LAND USE APPLICATION - COMPLETENESS REVIEW

Subject Property:	5660 Commercial Street SE
Reference Number:	24-115890
Application Type:	Class 2 Site Plan Review
Date Application Accepted:	July 26, 2024
Applicant:	Marcus Lima marcusl@gbdarchitects.com
Contact:	Same as applicant

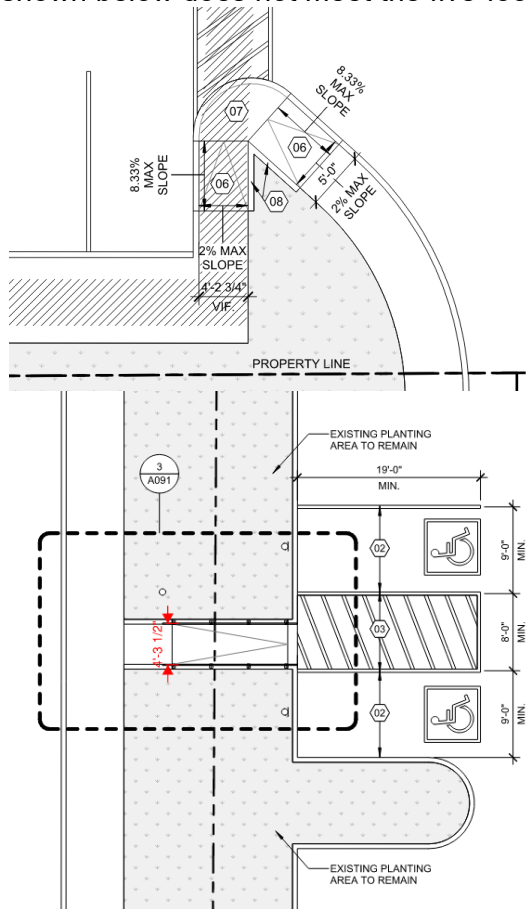
800.065(b)(1)(A) Width of Pedestrian Paths	<p>All areas altered need to meet required five-foot width for pedestrian connections. The areas shown below does not meet the five-foot width.</p>  <p>Please alter these to show the required 5 foot width.</p>	<p>Addressed</p>
